Marked-up Revised Response
to NRC RAI No. 02.05.01-17 (eRAI 6024)

The following revised text in the last paragraph of FSAR Subsection 2.5.1.2.2, Site Area Stratigraphy, and additional paragraphs will be included in a future revision of the COLA.

The following revised text will be included in a future COLA revision to replace paragraphs 7 through 14 of FSAR Subsection 2.5.1.2.4, Site Geologic Hazards.

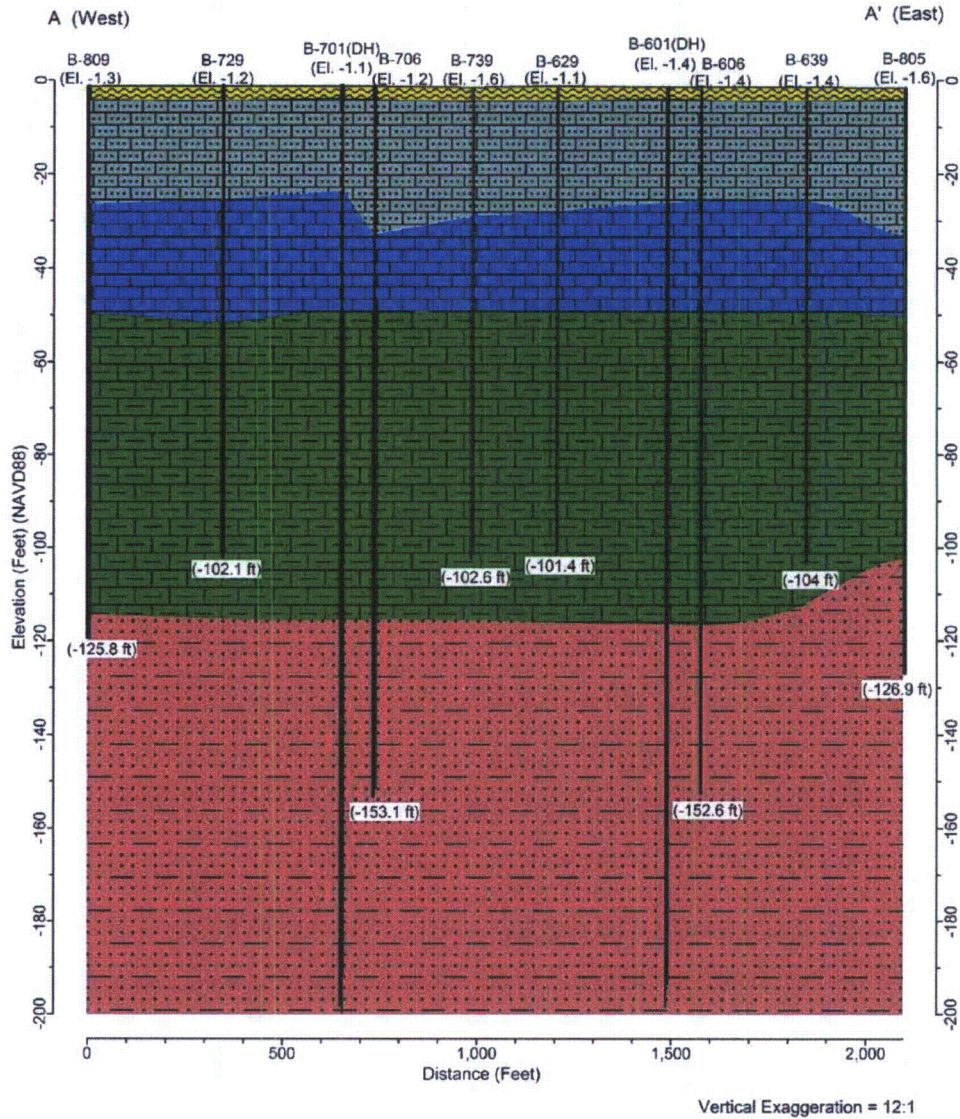
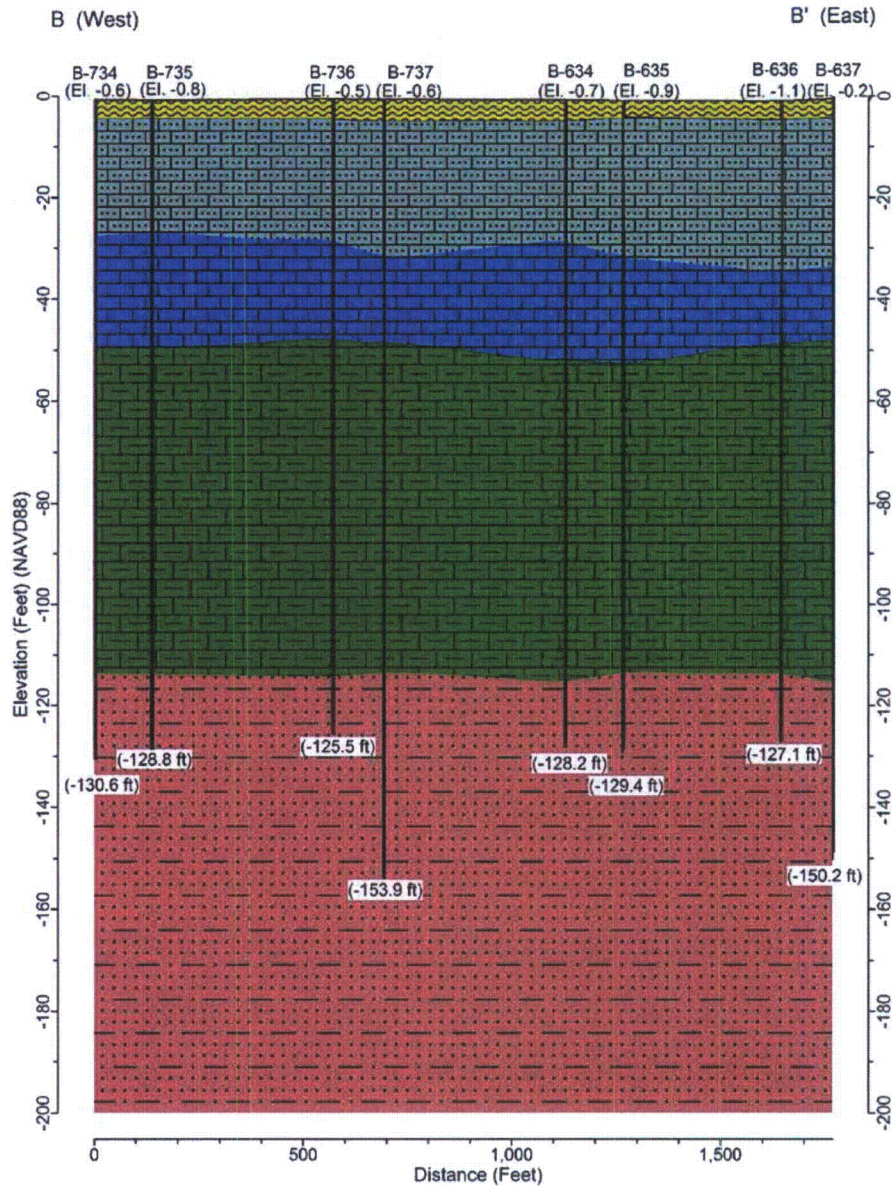
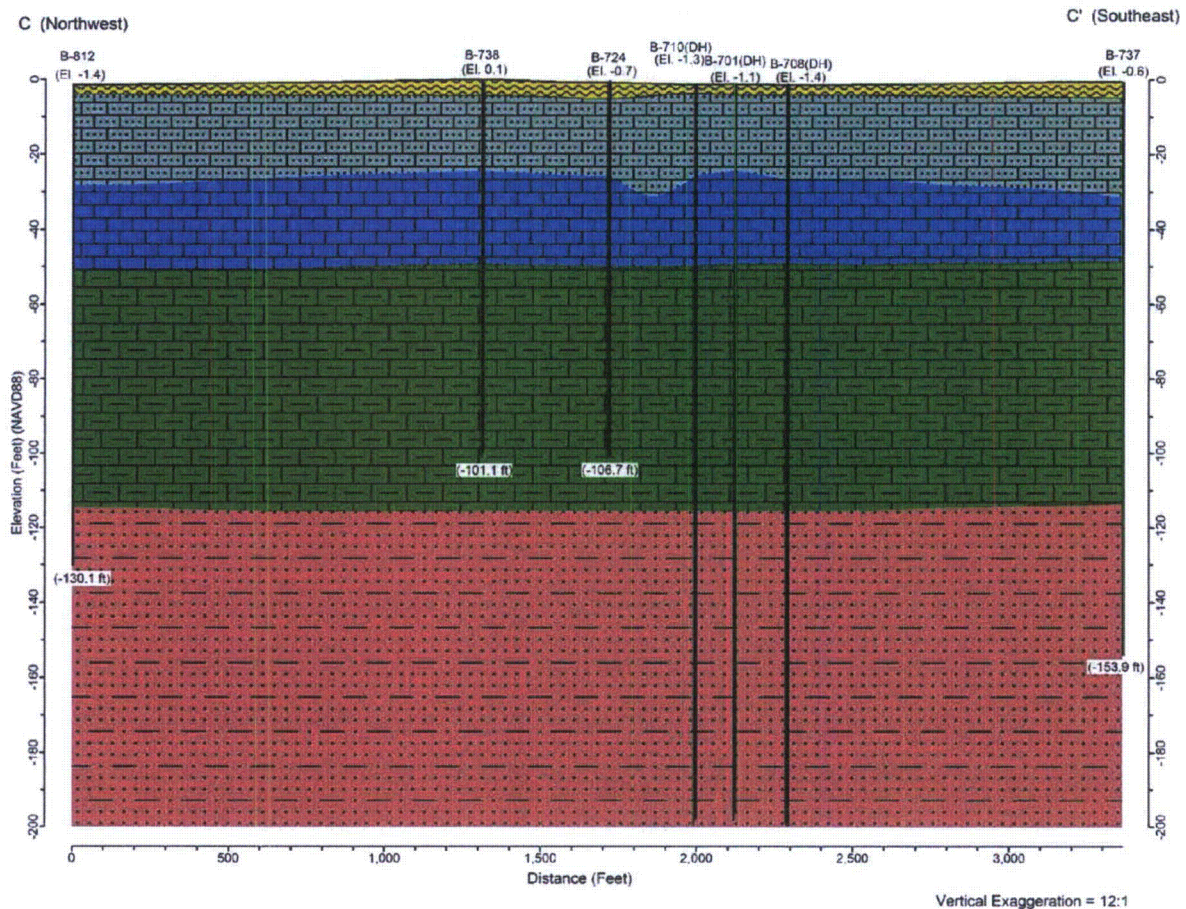
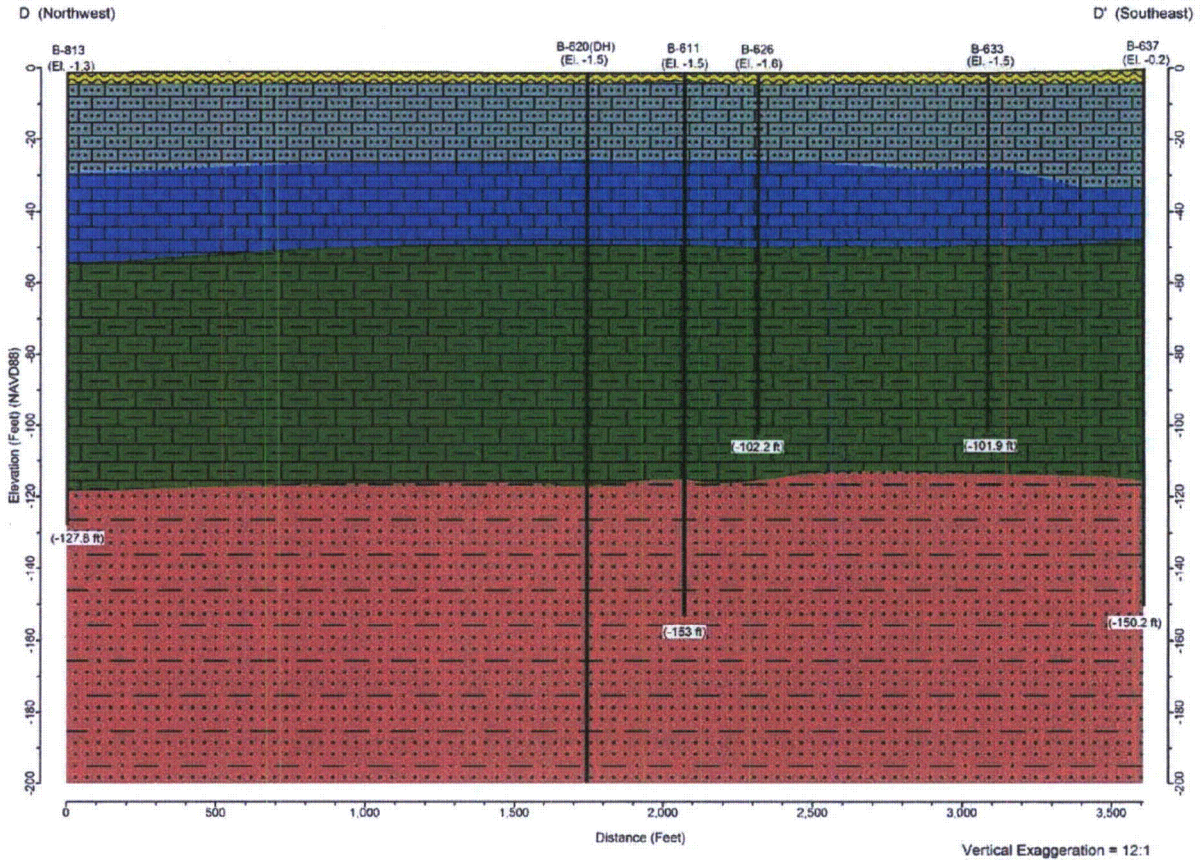
Four geologic cross sections, two isopach (thickness) maps, ~~one~~two structure contour maps, and a site geologic map were prepared from the information obtained from the site subsurface investigation (Figure 2.5.1-336~~4~~). Geologic cross section A-A' (Figures 2.5.1-338 and 2.5.1-386) extends east-west through the power blocks and eight borings, including the two deepest borings B-601 and B-701. Cross section B-B' (Figures 2.5.1-339 and 2.5.1-387) extends west-east through the southern edge of the site and includes eight borings, the deepest at 153 feet (46.6 meters) bgs. Cross section C-C' (Figures 2.5.1-340 and 2.5.1-388) extends diagonally northwest-southeast through the entire site and passes through the western power block. Cross section C-C' includes seven borings including the deepest boring, B-701(DH), at a depth of 615.5 feet (187.6 meters) bgs. Cross section D-D' (Figures 2.5.1-341 and 2.5.1-389) also extends diagonally northwest-southeast through the entire site but passes through the eastern power block. Cross section D-D' includes six borings; the deepest at a depth of 215 feet (66 meters) bgs.

The locations of the surface traces of the cross sections are shown on Figures 2.5.1-342 and 2.5.1-344 (isopach maps of the Key Largo Limestone and the Fort Thompson Formation, respectively) and Figures 2.5.1-349, and 2.5.1-343 (structure contour maps of the top of the Key Largo Limestone and the Fort Thompson Formation, respectively). Two versions of each of the four cross-sections are provided. Cross-sections in the first set (Figures 2.5.1-338, 2.5.1-339, 2.5.1-340, and 2.5.1-341) are truncated at the elevation of ~~-200 feet (-61 meters)~~ (-200 feet) NAVD88 and depict the subsurface stratigraphy with a vertical exaggeration of 12 to 1. Figures 2.5.1-386, ~~-387~~, 2.5.1-388, and 2.5.1-389 depict a thicker section of the subsurface stratigraphy on the same cross-sections with a vertical exaggeration of only 4 to 1.

The cross sections indicate that geologic contacts beneath the site are relatively flat and undeformed. This stratigraphy reflects the environment of deposition and subsequent erosion of the paleosurface. This is represented by ~~The flat and undeformed nature of~~

Figure 2.5.1-342 Isopach Map of the Key Largo Limestone
This figure appears in Appendix 2.5AA as Figure 2.5AA-207

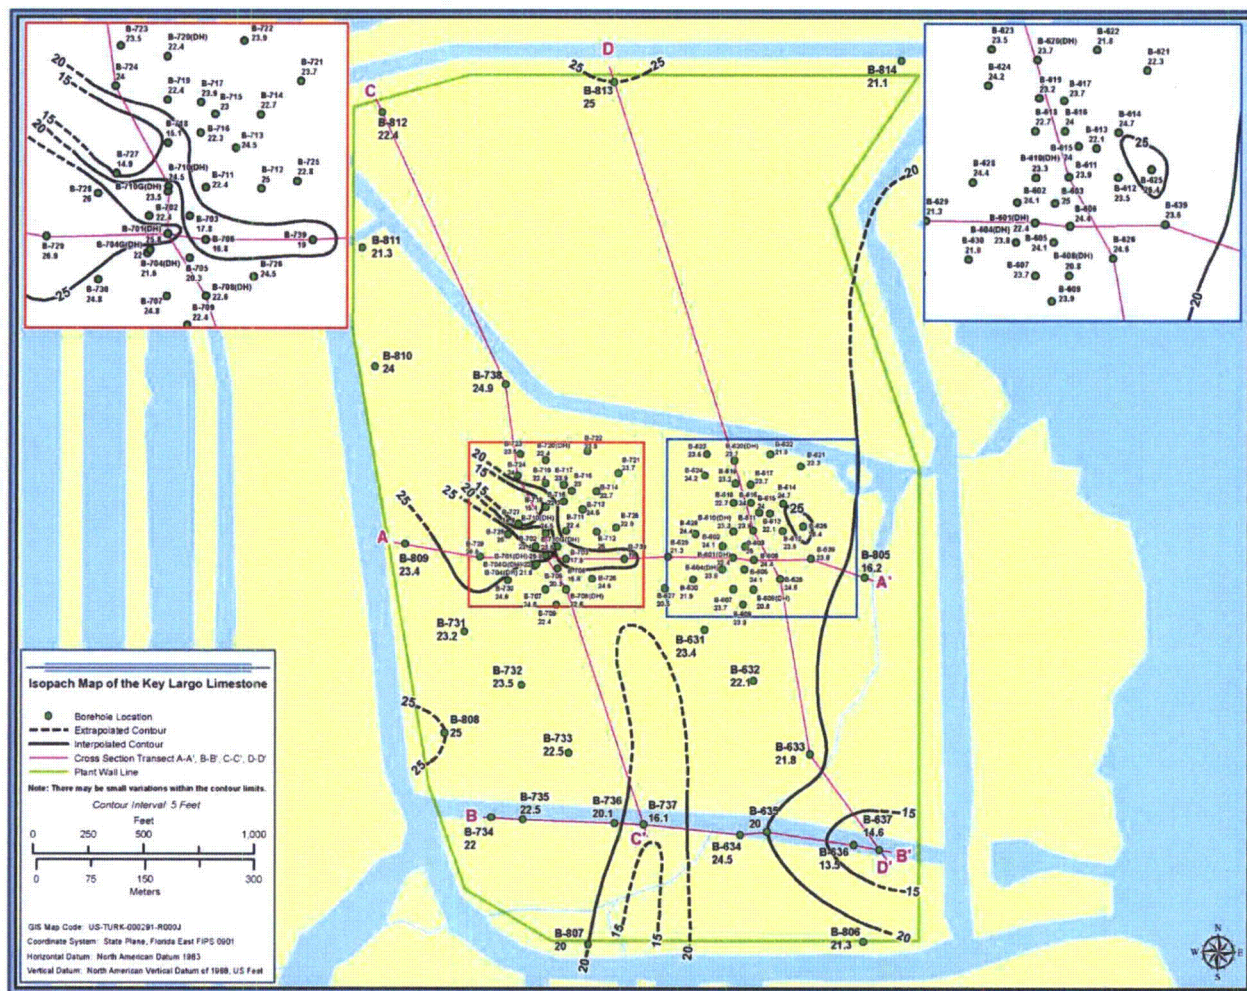
the geologic contacts is reflected in the isopach maps of the Key Largo Limestone (Figure 2.5.1-342) and the Fort Thompson Formation (Figure 2.5.1-344) that indicate a relatively uniform thickness across the site with no abrupt changes. **A**The structure contour maps of the top of the **Key Largo Limestone (Figure 2.5.1-349) and the** Fort Thompson Formation **(Figure 2.5.1-343)** show a relatively flat paleosurface (Figure 2.5.1-343). Boring logs and descriptions of the lithology are included in the geotechnical data report in References 708 and 995. **Section 5.3 of Appendix 2.5AA provides a discussion of the isopach and structure contour maps and reasons for concluding that they provide no strong evidence for the presence of large collapse features in the Key Largo Limestone or Fort Thompson Formation at the site.**

Figure 2.5.1-351 The two zones of secondary porosity on B-604 (DH) showing the lithology, caliper, natural gamma, velocity (Vs and Vp) and acoustic televiewer logs (3 pages)

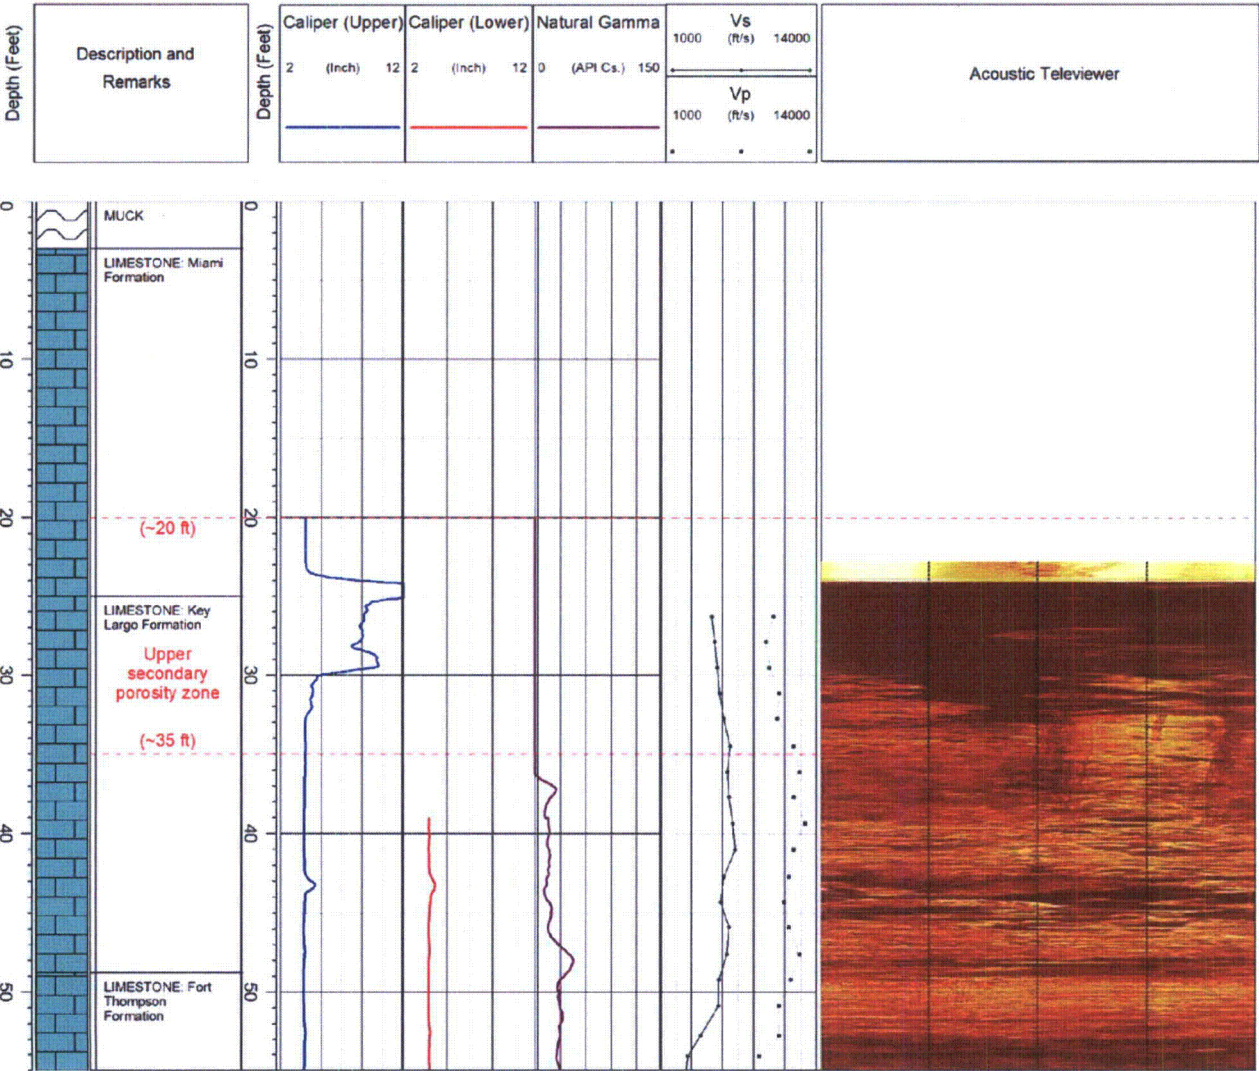
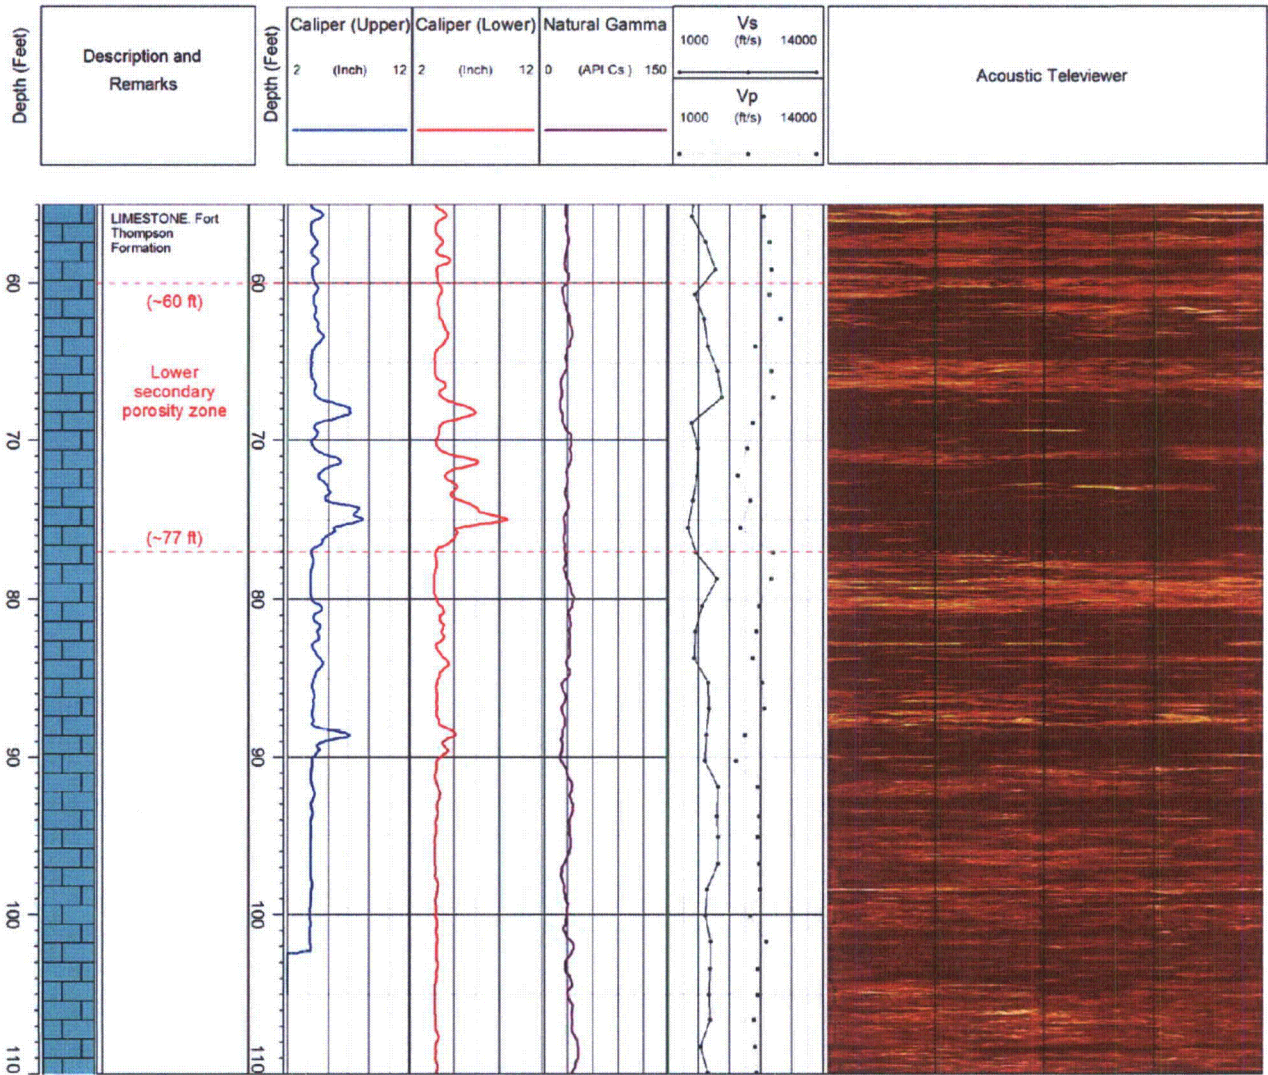
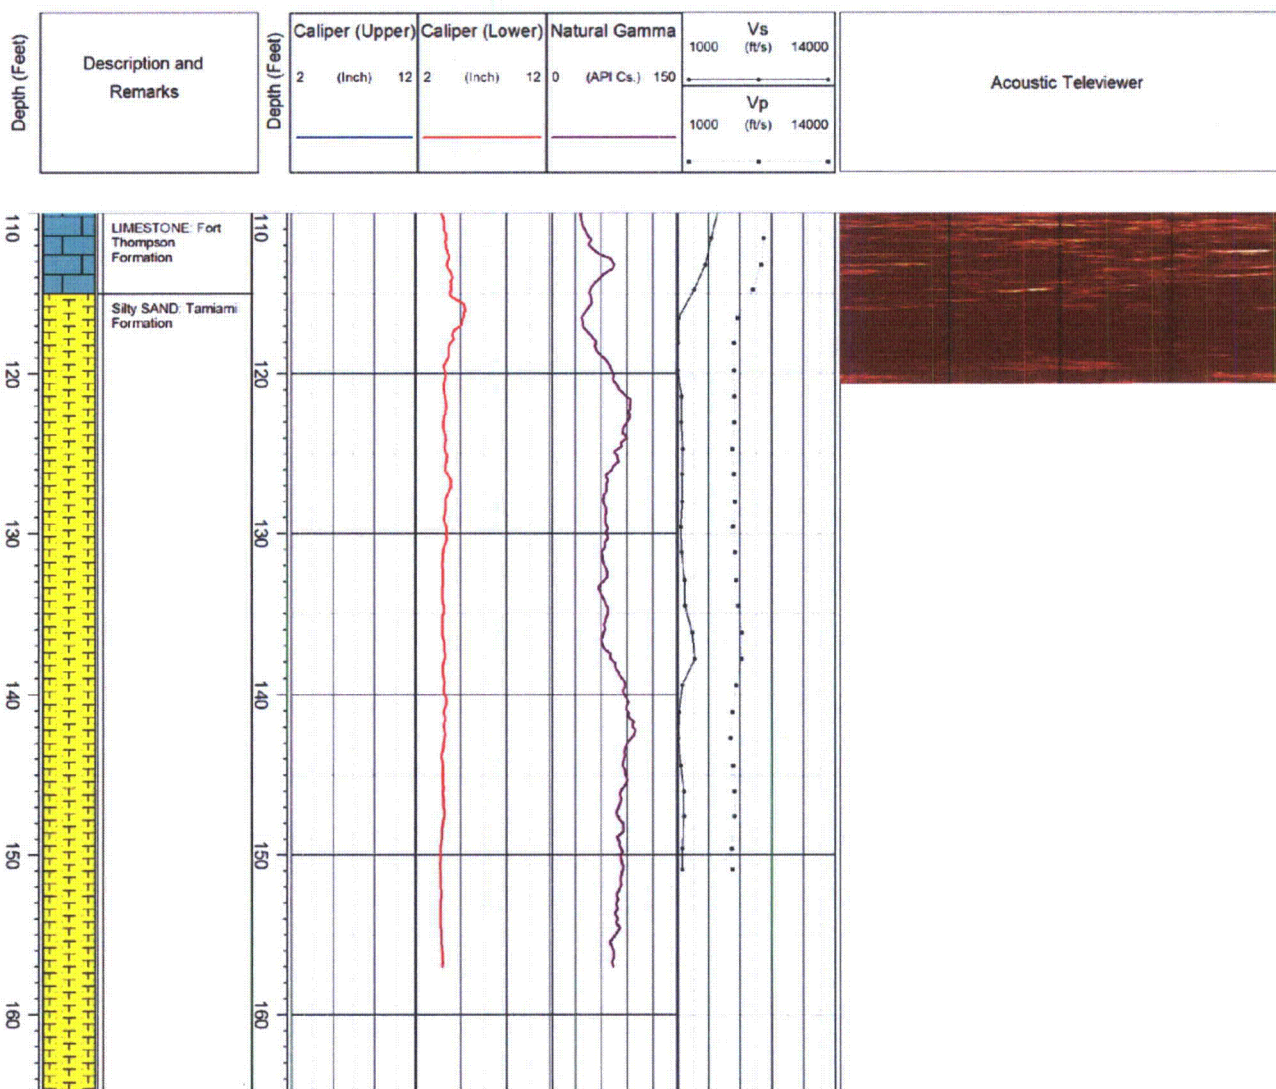
Touching-vug porosity occurs on the site within the approximate depth interval of 20 to 35 feet (Figures 2.5.1-351, 2.5.1-352, and 2.5.1-353) near the contact of the Miami Limestone and Key Largo Limestone (the "Upper Zone" of secondary porosity discussed in FSAR Subsection 2.4.12.1.4). Because the elevation of ground surface at the site is approximately 0 feet NAVD88 (Reference 708), this depth interval corresponds approximately to -20 to -35 feet NAVD88. The origin of this porosity is solution enlargement of burrows, inter-burrow vugs, moldic fossils, root molds, and vugs between root casts (References 404, 723 and 969). These structures are sufficiently numerous and closely spaced so as to form a laterally continuous zone of interconnected voids. Results of drilling and coring within the zone of touching-vug porosity during the site subsurface investigation have shown the feature to be laterally persistent, generally of centimeter scale, with very few indications of possible larger voids such as a rod drop.

Moldic porosity occurs in pockets within the approximate depth interval of 60 to 75 feet (-60 to -75 feet NAVD88) (Figures 2.5.1-351, 2.5.1-352, and 2.5.1-353) in the Fort Thompson Formation and forms the "Lower Zone" of secondary porosity discussed in FSAR Subsection 2.4.12.1.4. The origin of this feature is preferential dissolution of fossil shells and other organic structures rather than the matrix rock within which they are contained, resulting in void spaces of generally centimeter scale within molds of the structures (References 404, 723 and 969).
